Access Compliance Report

Public Rights-of-Way

Intersection ID: 14086	Main Street: BALDWIN_AV	Cross Street: E_3RD_ST	Location: SW
ADA ID: FB7AD5335631	Ramp Type: Perp	Initial Pass/Fail: Fail	Overall Compliance: No
		Severity Score: 30

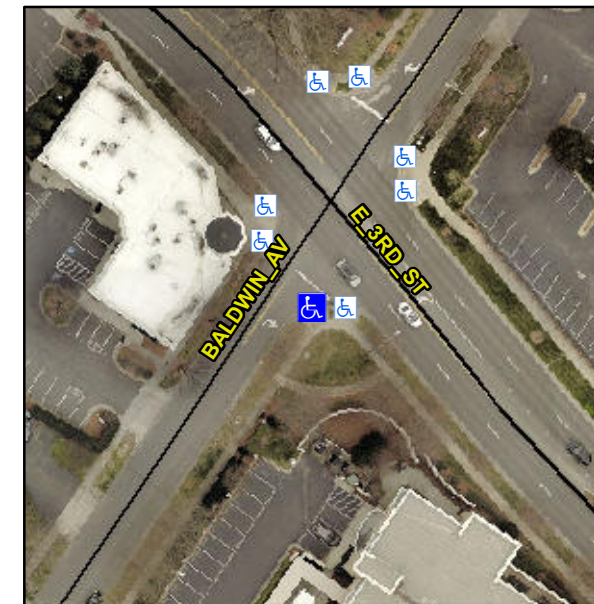
R304.5.1, R304.2.2

Compliance	Description	Data	Compliance	Description	Data
N/A	Ramp Length (in)	85.5	No	Ramp Slope (%)	9.5
No	Ramp Width (in)	34.5	Yes	Ramp XSlope (%)	1.0
N/A	Flare Type LT	N/A	N/A	Flare Type RT	N/A
N/A	Flare Slope LT (%)	N/A	N/A	Flare Slope RT (%)	N/A
N/A	Flare Traversable LT?	N/A	N/A	Flare Traversable RT?	N/A
N/A	Landing Length (in)	N/A	N/A	DWS Provided?	N/A
N/A	Landing Width (in)	N/A	N/A	DWS Contrast?	N/A
N/A	Landing Slope (%)	N/A	N/A	DWS Length (in)	N/A
N/A	Landing X Slope (%)	N/A	N/A	DWS Full Width?	N/A
N/A	Landing Curb? (Y/N)	N/A	N/A	DWS Offset (in)	N/A
N/A	Shared Landing?	N/A			
N/A	Gutter Ponding?	N/A	N/A	Gutter Slope (%)	N/A
N/A	Gutter Lip Ht (in)	N/A	N/A	Gutter X Slope (%)	N/A
N/A	Painted X Walk1?	No	N/A	Painted X Walk2?	N/A
	X Walk 1 Direction	To NW		X Walk 2 Direction	N/A
N/A	X Walk 1 Width (in)	N/A	N/A	X Walk 2 Width (in)	N/A
	X Walk 1 Slope (%)	0.5		X Walk 2 Slope (%)	N/A
	X Walk 1 X Slope (%)	1.0		X Walk 2 X Slope (%)	N/A

Remove & Replace Entire Ramp.
